**SUBJECT:** DE 08-003: Petition by National Grid for a License to Construct and Maintain Electric Lines and a Communication Line Over and Across the Public Waters of the Connecticut River and Cold River in Walpole, New Hampshire and the Ashuelot River in Surry, New Hampshire

**Review by The Liberty Consulting Group of the National Grid Petition for License to Construct and Maintain Electric Lines and a Communication Line Over and Across the Public Waters of the Connecticut and Cold Rivers in Walpole and the Ashuelot River in Surry, New Hampshire**

**March 30, 2009**

**I-135N CROSSING OF CONNECTICUT RIVER**

Photo 11-5-08 #11

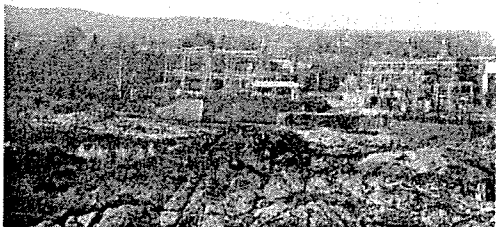
This photo was taken from the New Hampshire side of the river on New Hampshire Route 12 looking west towards the station and directly under another unidentified 115kV river crossing. The photo shows that there is a large rock mound under the line

Liberty further recommends that the applicant check the clearance of the rock mound under the unidentified 115kV line depicted in Photo 11-5-08 #11 at maximum operating temperature of the line to assure that National Electrical Safety Code requirements are met.
